# **Public Interest Evaluation of the Trans Mountain Expansion Project**

**May 2015**

School of Resource and Environmental Management

**Figure 1. TM/IHS Estimates of Western Canadian Supply for Pipeline Export vs. Pipeline Capacity**

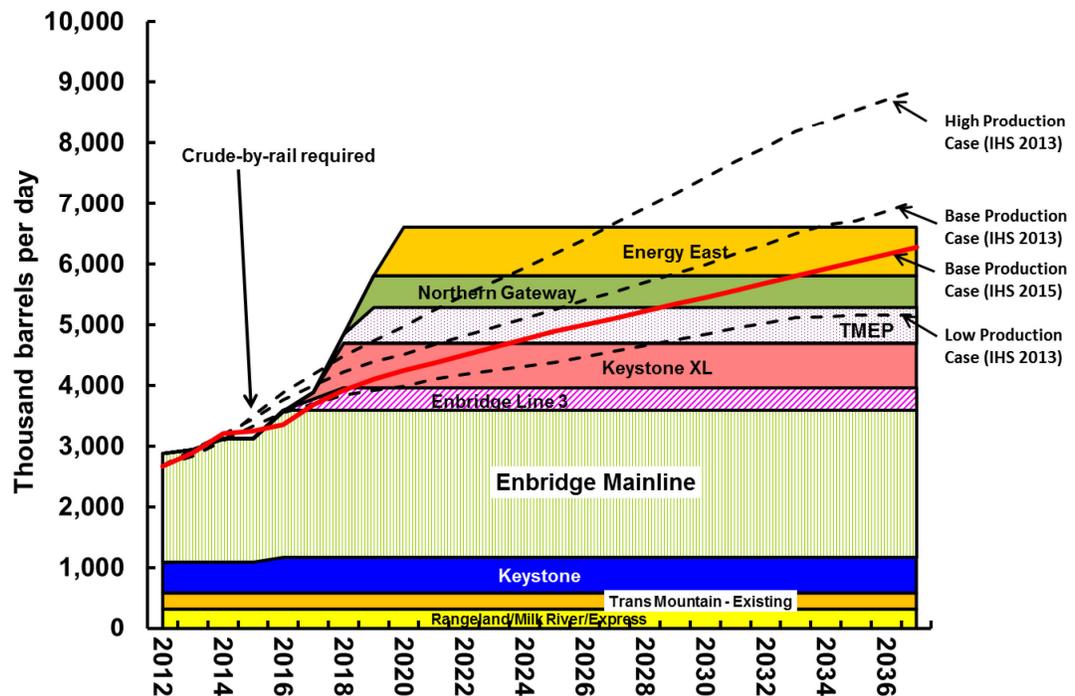
6. TM's analysis shows that construction of the TMEP will contribute to a large increase in surplus capacity in the oil transportation sector. TM estimates in its original application that there will be 1.8 million bpd of surplus capacity by 2019 if all proposed transportation projects proceed as planned. Based on TM's updated forecast (TM 2015a), surplus capacity is now estimated to be approximately 2.5 million bpd in 2019. TM's updated base case forecast shows that if all proposed projects proceed as planned there will be surplus pipeline capacity beyond 2037 (Figure 1). Surplus capacity may be even higher than TM's forecast because TM excludes rail transportation in its estimates. This unused capacity would impose a large cost on Canada's oil transportation sector, oil producers and the Canadian public in the form of reduced tax revenues. TM has not included the costs of this unused capacity in its evaluation of TMEP costs and benefits.

149 **Figure 2. TM/IHS Estimates of Western Canadian Supply for Pipeline Export vs. Pipeline**  
 150 **Capacity**

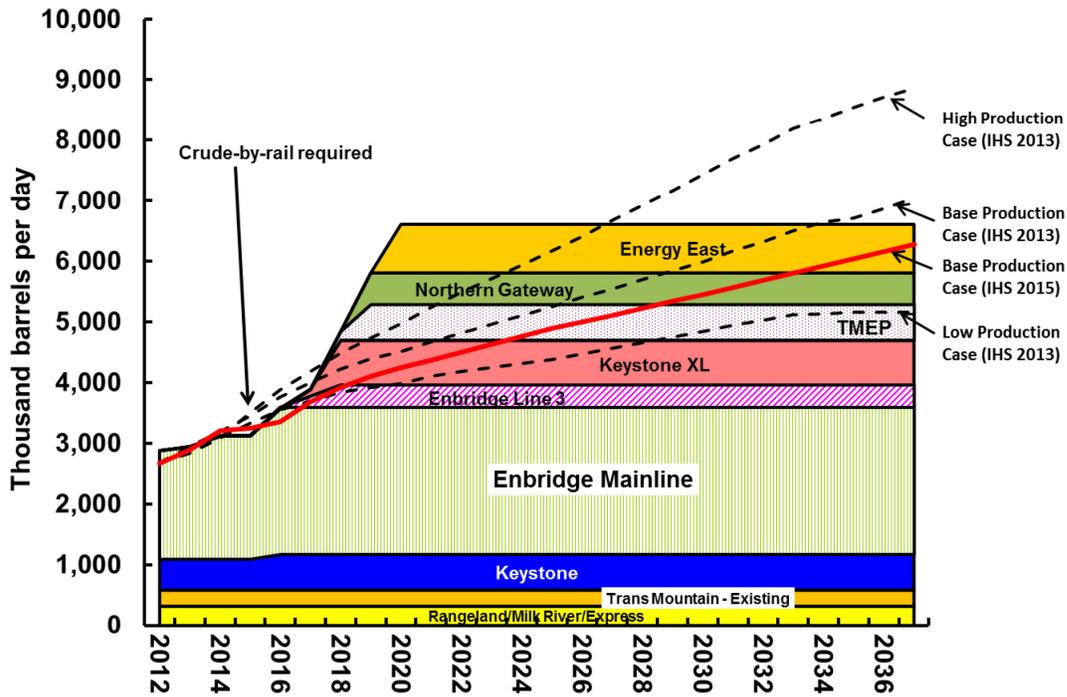
153 Although IHS estimates that there will be significant surplus pipeline capacity if all planned  
 154 projects proceed, the IHS forecast suggests that there may be need for some new pipeline  
 155 capacity in the future. Whether and when TMEP is required depends very much on what oil supply  
 156 forecast one assumes and what other new pipeline capacity is developed.

157 Based on IHS's 2015 Base oil production forecast, and assuming Enbridge line 3 and  
 158 Keystone XL go ahead, additional pipeline capacity would not be needed until 2024. If either  
 159 Energy East or TMEP are built, there would add enough capacity until after 2028 under the 2015  
 160 base case assumption and until after 2037 under the 2013 low production assumption. Adding  
 161 TMEP capacity based on TM's proposed schedule, therefore, will create unused capacity that will  
 162 simply divert oil shipments from other pipelines for much of the forecast period. It should also be  
 163 noted that Figure 2 does not include existing and proposed rail capacity. If rail capacity is  
 164 included, the unused capacity would be even higher.
